STAFF REPORT
Director's Hearing
January 31, 2023

File: PLN17-10080

Appeal of the Open Space Easement Compatible Use Determination (CUD) for a New Single-Family Residence.

Owner: Martin & Rosario Gutierrez
Applicant: Hanna-Brunetti/D&Z Designs
Lot Size: 27.1 acres
APN: 728-24-008
Supervisorial District: 1

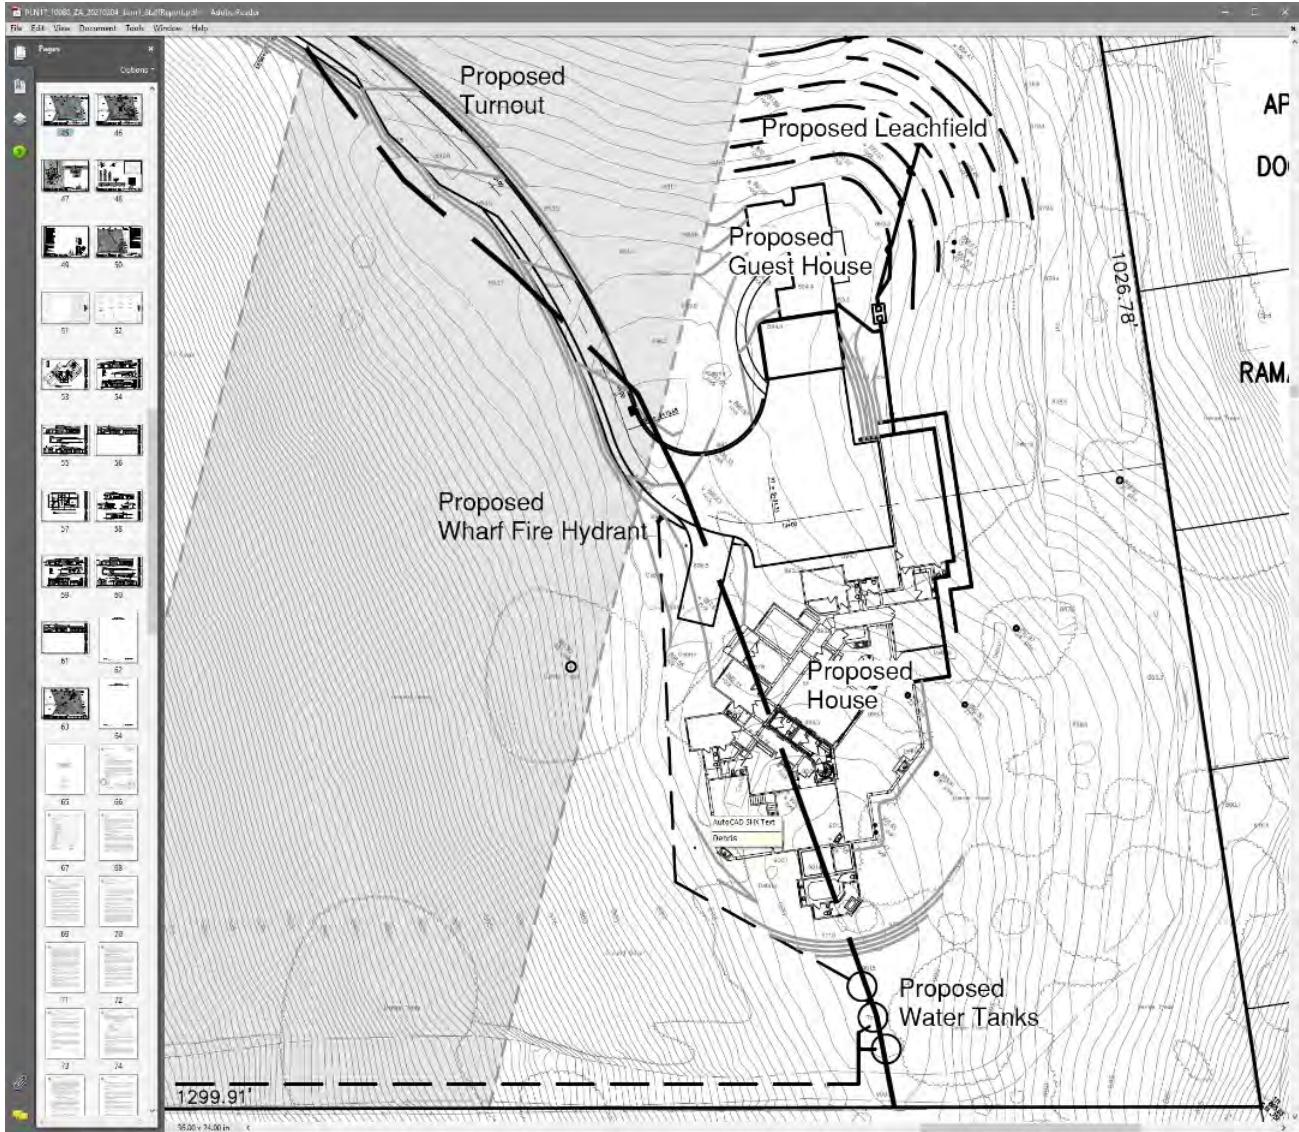
Despite all the assertions that the development is not on a ridgeline, the plans themselves appear to show otherwise. The below screen shot of Sheet 2 of the plan shows the watershed divide line proceeding directly through the front door of the proposed Primary Residence, and continuing through the residence and then through the proposed water tanks.

When watershed lines run along ridges, they typically run along the highest portions of the ridge. The County Planner has stated that this line IS the watershed line, but not a ridgeline. However, when looking up the definition of a ridgeline at dictionary.com, we find the following definitions:

The watershed line satisfies the second definition, and to satisfy the first, we merely need to zoom in a bit and look at the topographic lines and labeled elevations:

Sheet 2 of the plan above clearly shows the highest elevations for each section of ridge lie under the Proposed House. Additionally, to the 'left' (southwest) of the house (towards the valley in Morgan Hill), elevations drop off rapidly, and to the 'right' (northeast) of the garage, elevations also drop fairly quickly.

The proposed single-family residence is situated adjacent to a ridgeline and the driveway (from Barnard Road to the house) is on top of a ridgeline. The *County’s General Plan*, specifically policies for Ridgeline and Hillside Development, *R-GD33* and *R-GD34* (Attachment H), states that building sites may be approved on ridgeline or hillside development “where consistent with the grading policies of the General Plan and the permit requirements and findings of the Grading Ordinance” and that “if

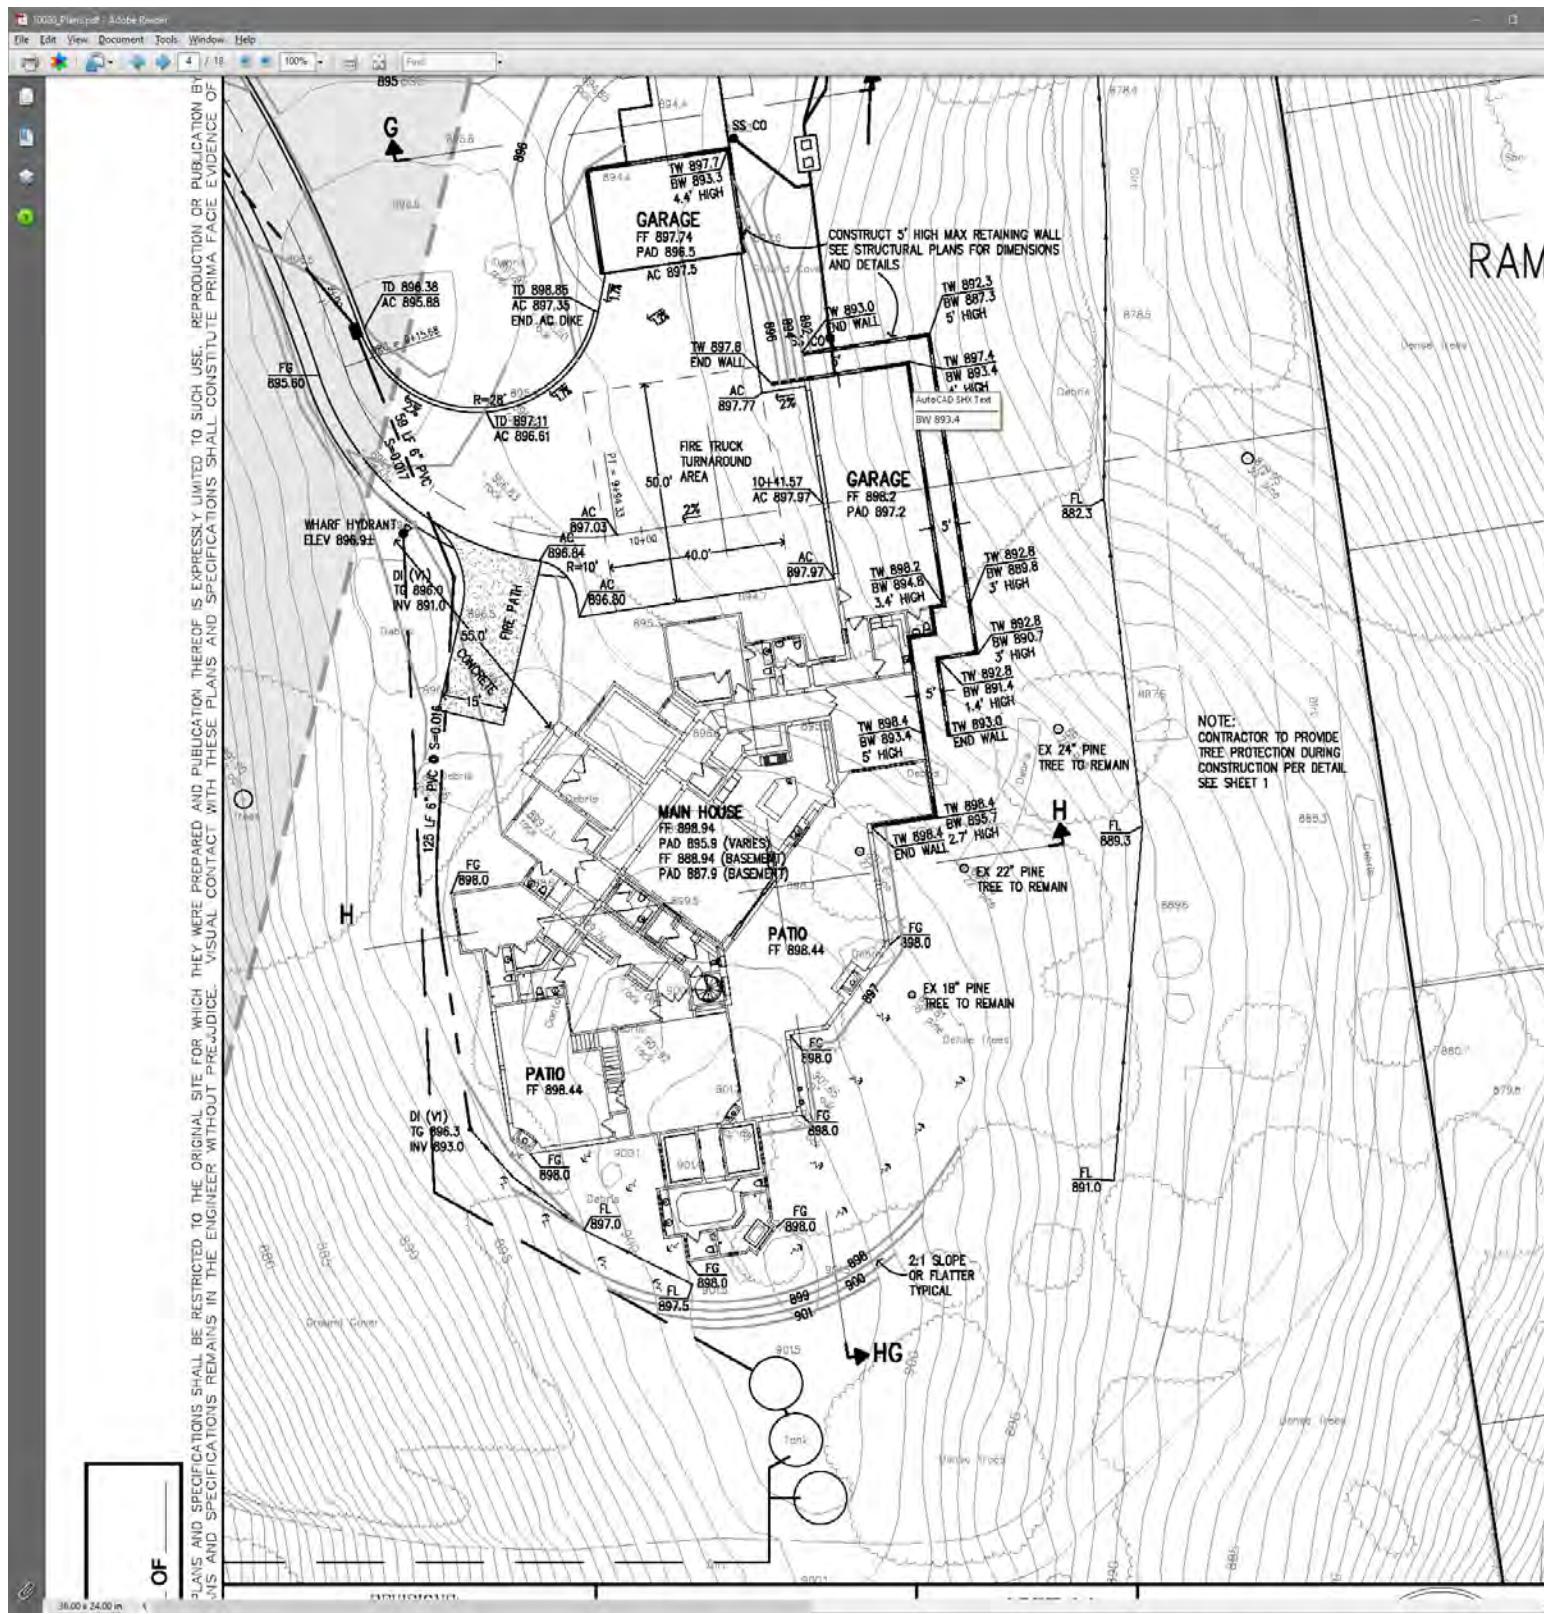
Despite all the assertions that no trees will be removed, this does not appear to be the case. On plan sheet 2, there are many trees shown adjacent to the project, some labeled as pines (with diameters up to 30") + markings of 'Dense Trees'.

Staff's Response: The project will require the removal of three (3) pine trees for the development of the proposed residence. The previous unpermitted tree removal resulted in the removal of eleven (11) trees. However, to address the removal of trees on the property, the Owner/Applicant is proposing an updated landscaping and tree planting plan that will replant a total of 185 trees on the property that includes Coast Live Oak, California Pepper, Strawberry trees, and Purple Leaf Hopseed. Landscaping and tree planting conditions have been incorporated in the preliminary Conditions of Approval to help further screen and soften the retaining walls and mitigate any potential visual impacts to the side neighbors.

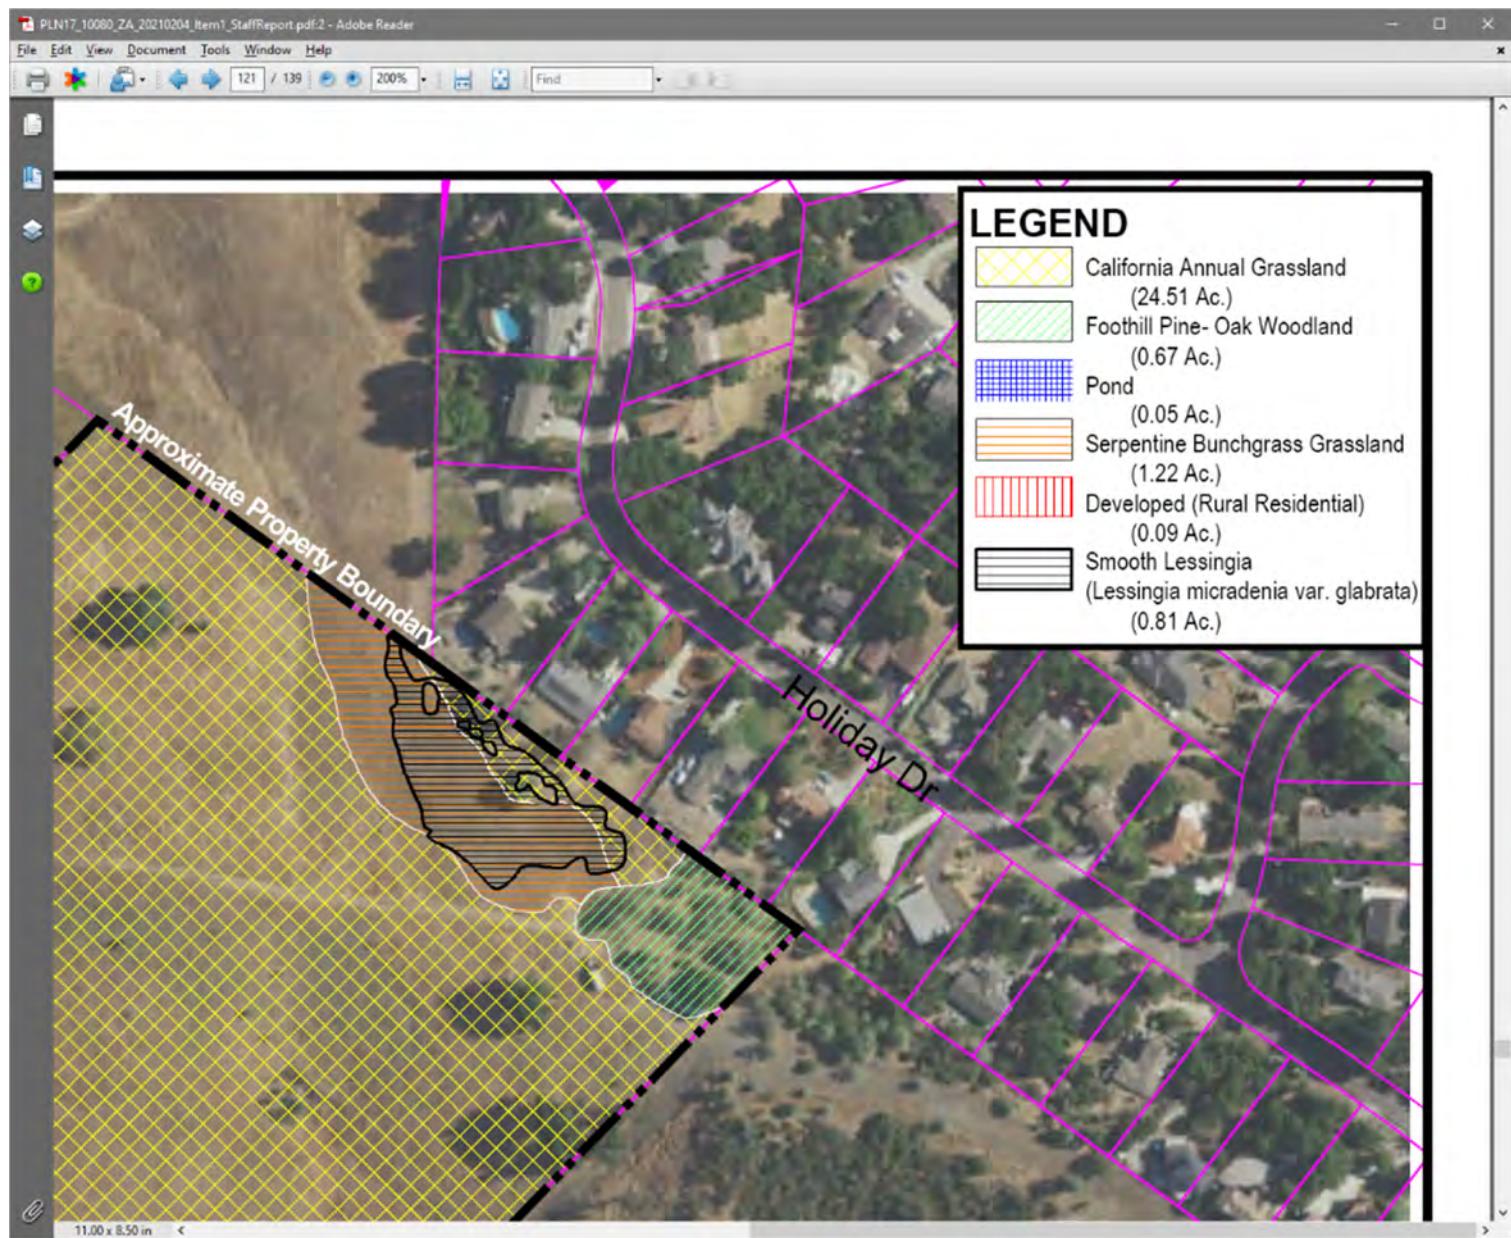
On Plan Sheet 4, it shows many large pines, of sizes 18", 22", 24" that are labeled 'EX Pine Tree To Remain' with the size listed. Additionally, a 22" pine is clearly located inside of the proposed Main House, and a 30" tree is labeled near the property line to the right.

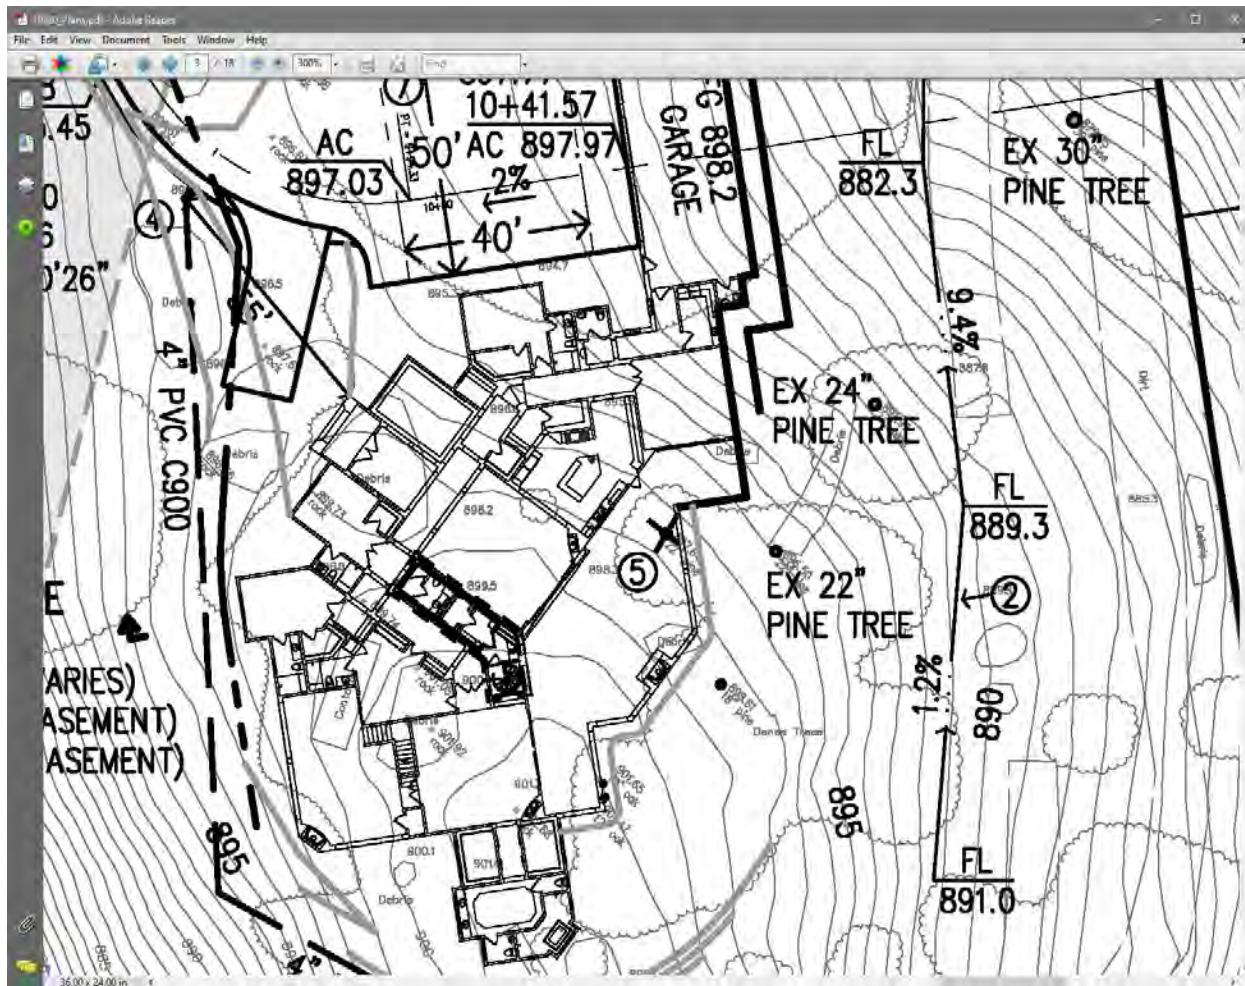
It appears that even the large pines that the plan says will remain have been removed, as well as a 30" pine adjacent to the lot border with Holiday Lake Estates. The aerial images appear to show that the majority of the trees adjacent to the proposed development site were removed between late 2017 and late 2018, which was either immediately before or during the application process.

Finally, even the plans indicate a tree to be removed. On plan sheet 3, it clearly labels the 22" tree within the house to be removed as an 'existing tree to be removed.' This tree is labeled with a (5) below:
